**Addendum No. 001**

**Subject: 2020 Classroom Modernizations**  
**SDP Contract Numbers: B-028 C of 19/20 & B-030 C of 19/20**

**Location: Overbrook Educational Center**  
**6722 Lansdowne Ave, Philadelphia PA 19151**

**This Addendum, dated March 6, 2020, shall modify and become part of the Contract Documents for the work of this project. Any items not mentioned herein, or affected by, shall be performed strictly in accordance with the original documents.**

DRAWING NO.  
**ED1.2**

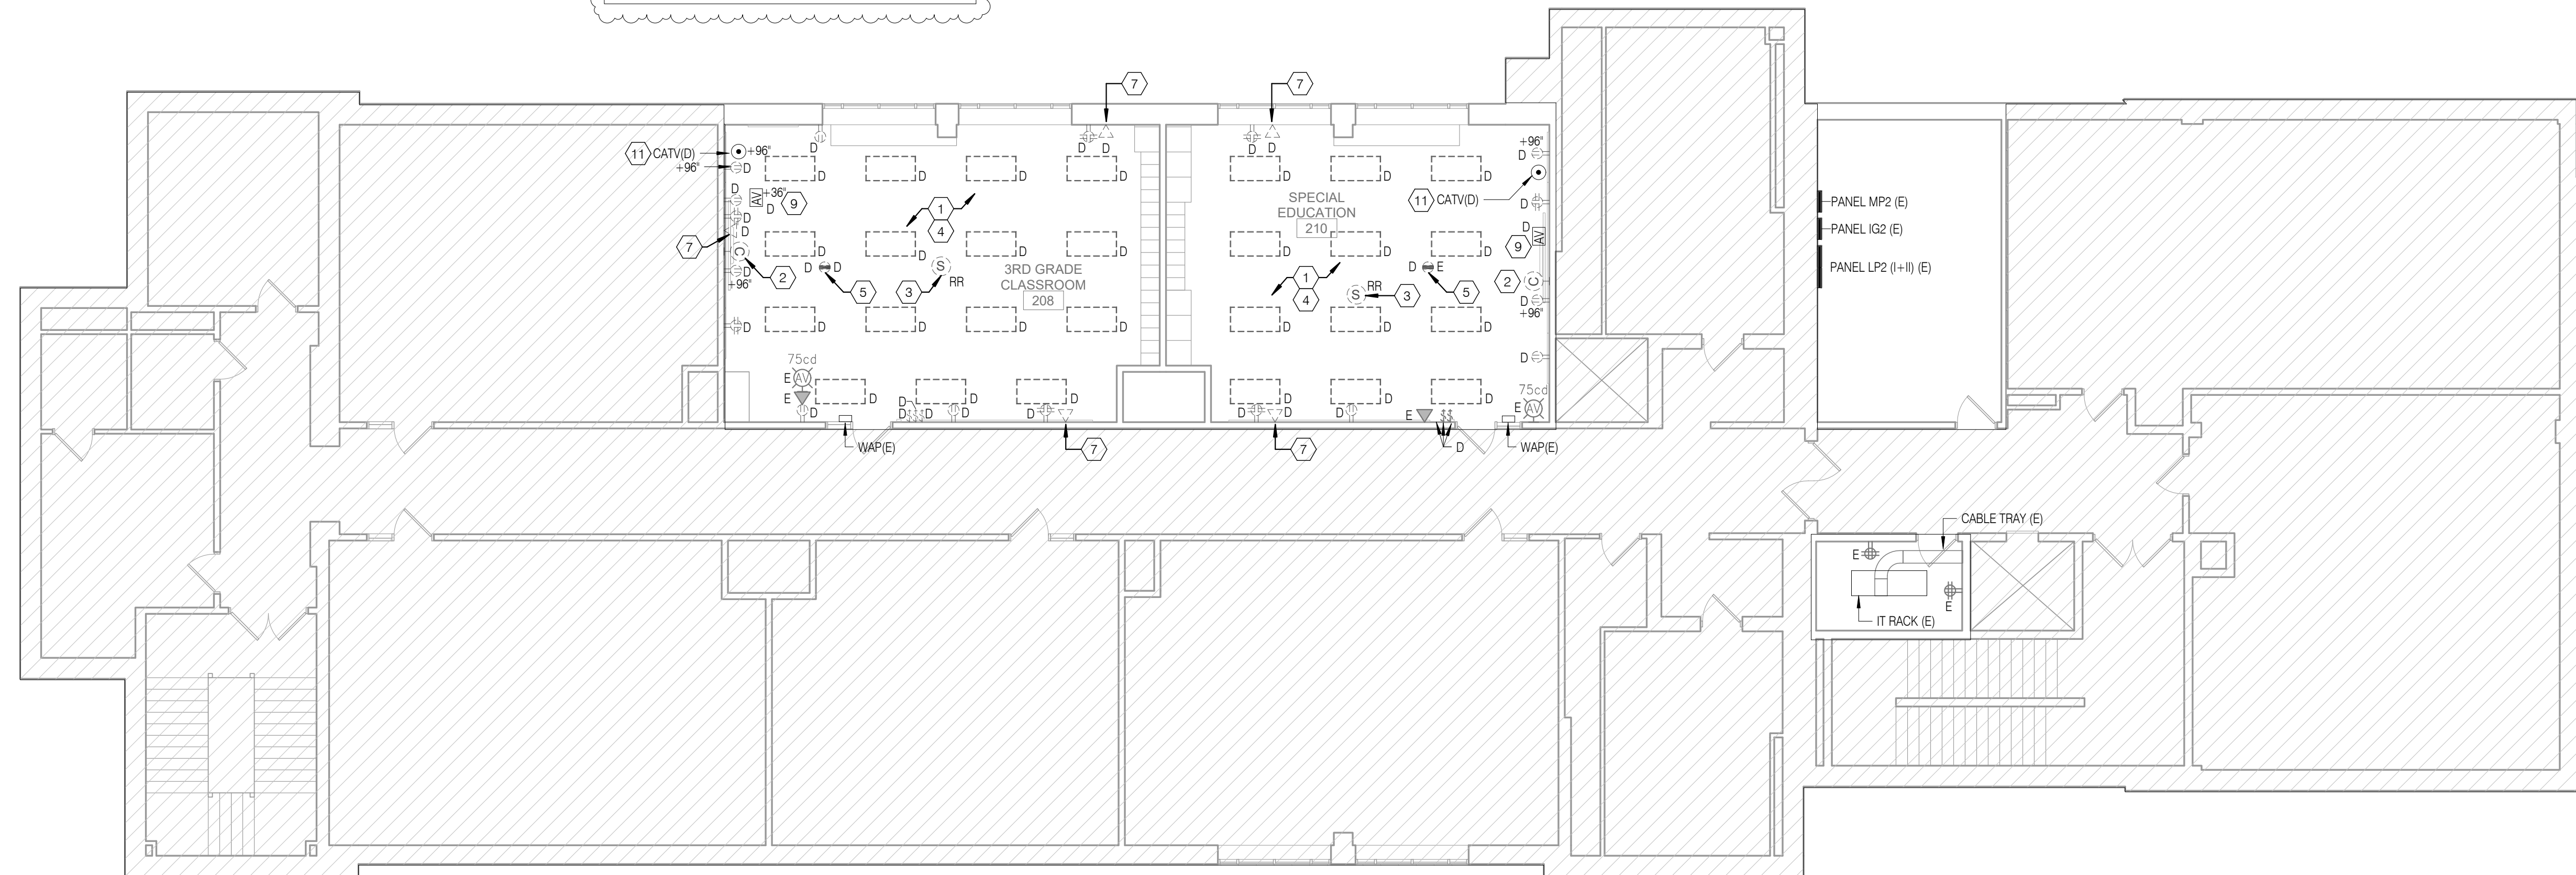
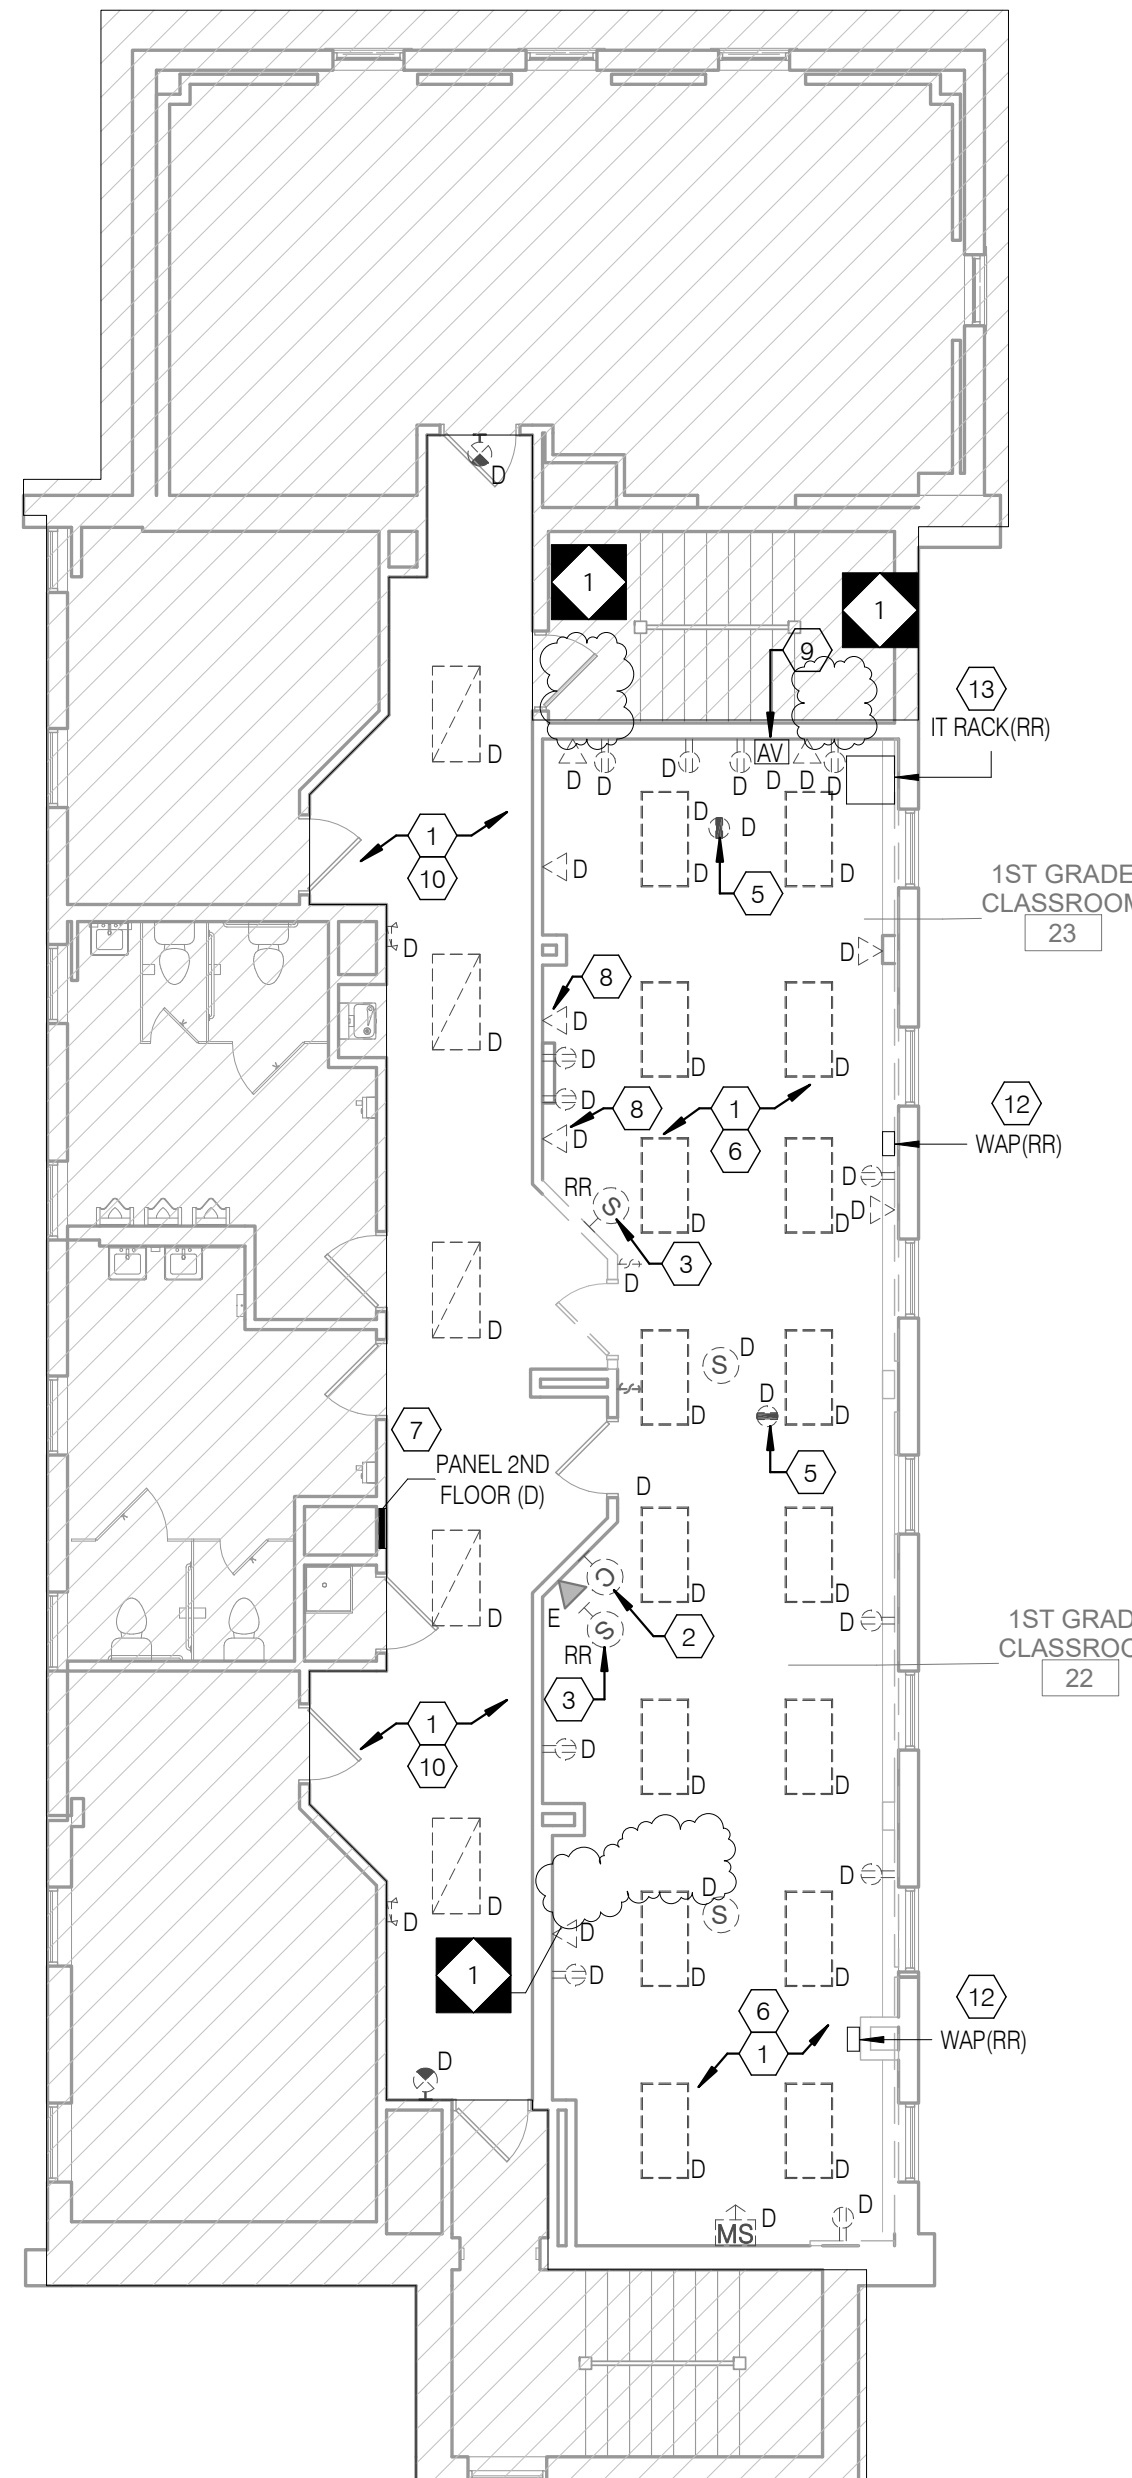
1. DELETE Key Note #7 from 3 existing data outlets as indicated on the drawings.
2. DELETE Key Note #3 from ceiling mounted speaker as indicated on the drawings.
3. CLARIFY general note in larger font to read "ELECTRICAL CONTRACTOR TO PROVIDE ALLOWANCE FOR REMOVAL OF 10'-0" OF SURFACE MOUNTED RACEWAY/ CONDUIT AND CONDUCTORS IN EACH CLASSROOM."

DRAWING NO.  
**ED1.3**

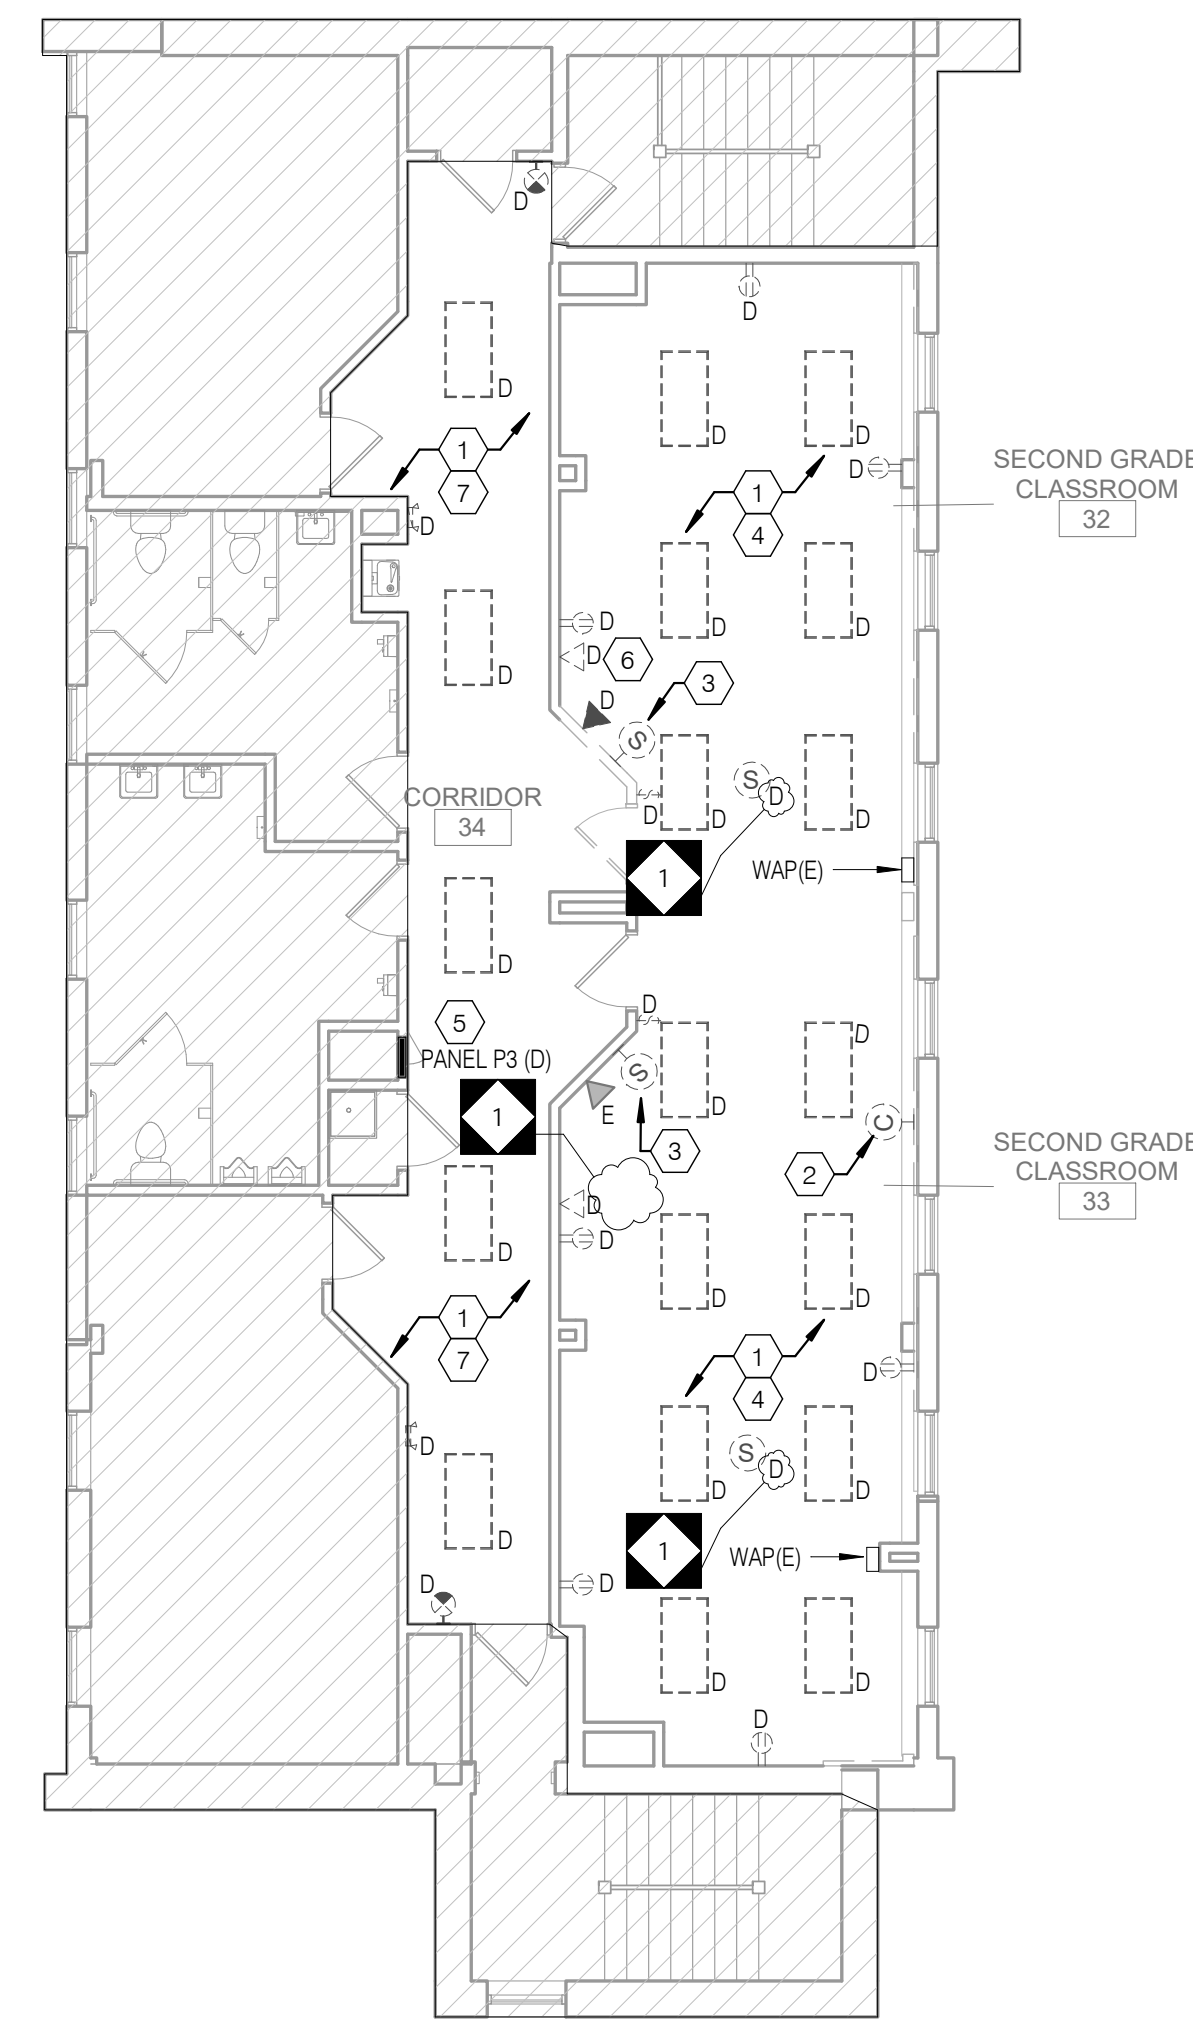
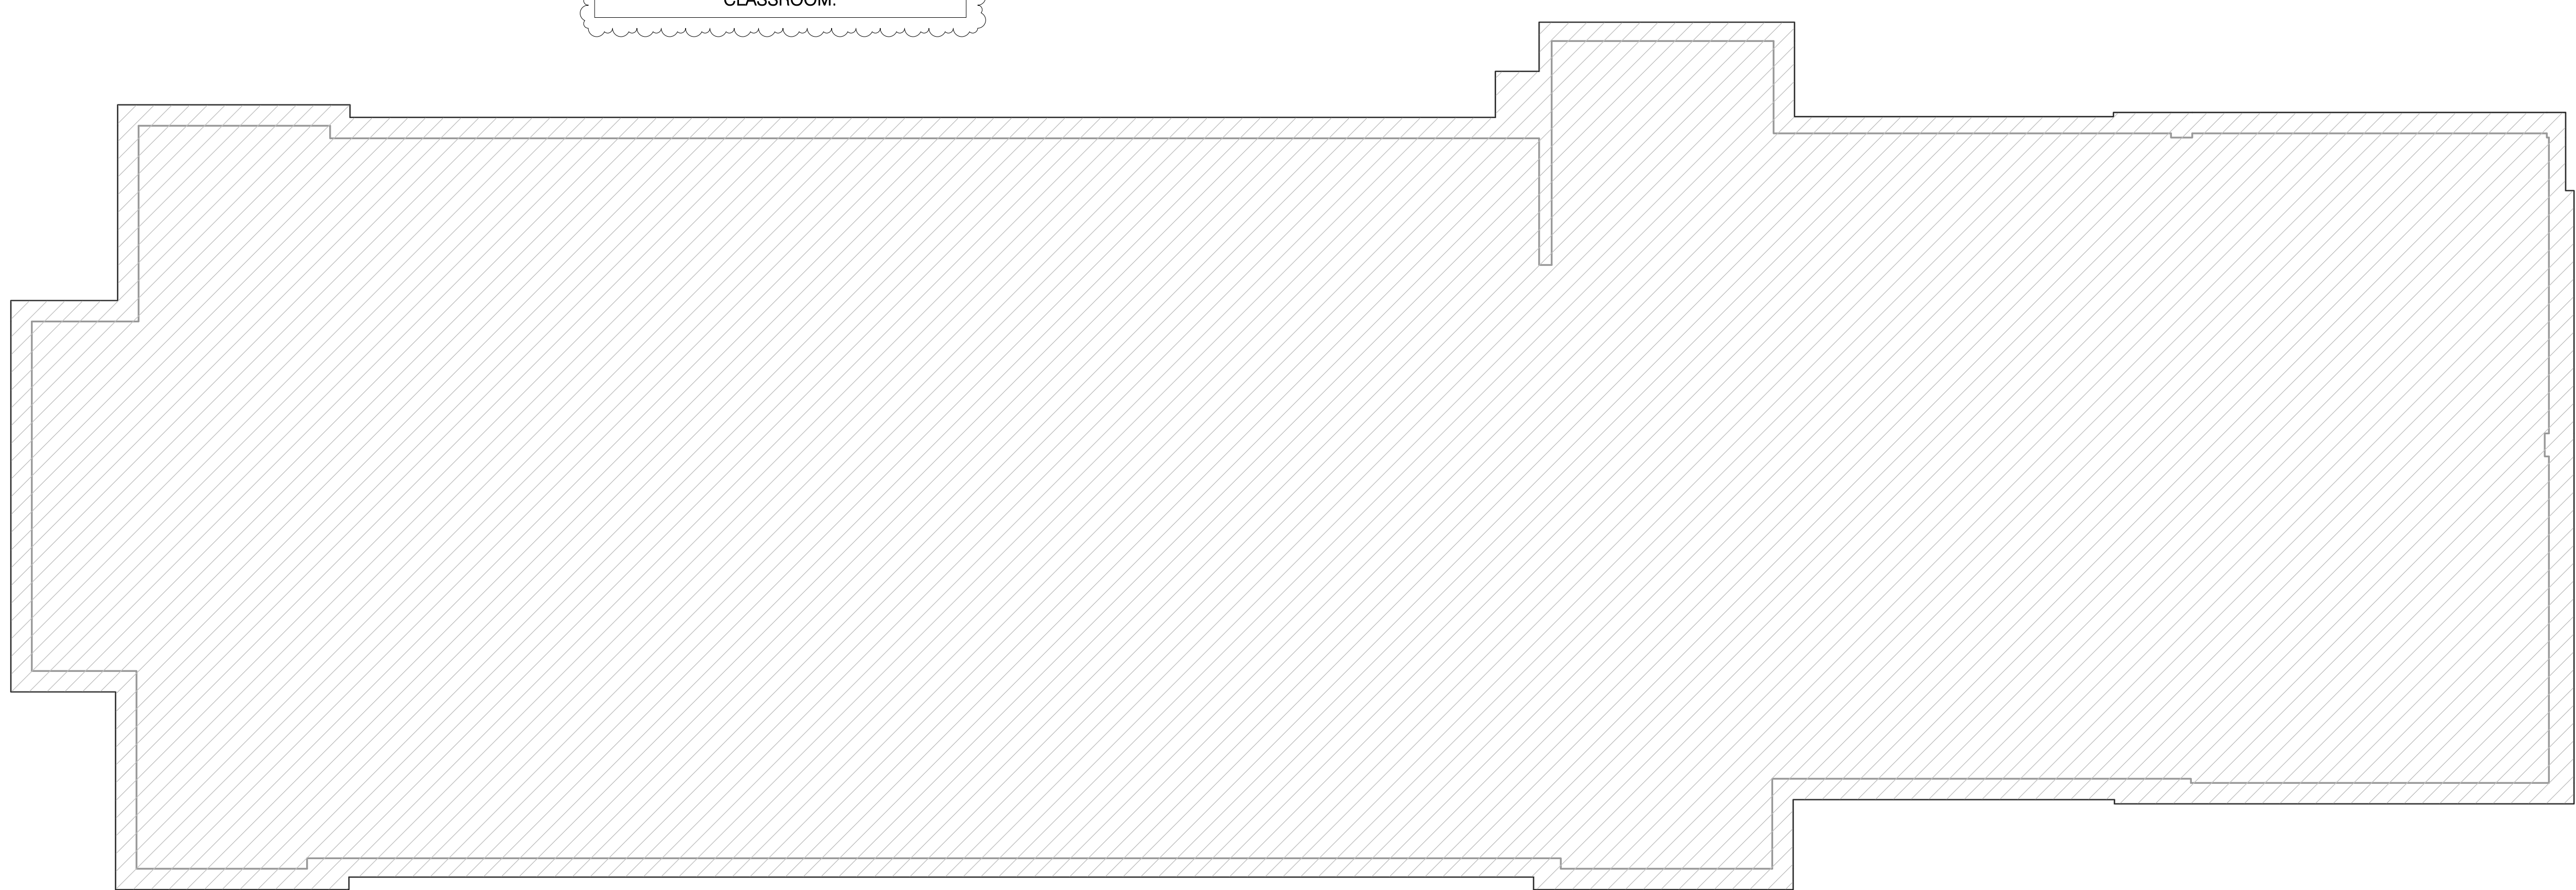
1. DELETE Key Note #7 from 1 existing data outlet as indicated on the drawings.
2. CLARIFY general note in larger font to read "ELECTRICAL CONTRACTOR TO PROVIDE ALLOWANCE FOR REMOVAL OF 10'-0" OF SURFACE MOUNTED RACEWAY/ CONDUIT AND CONDUCTORS IN EACH CLASSROOM."
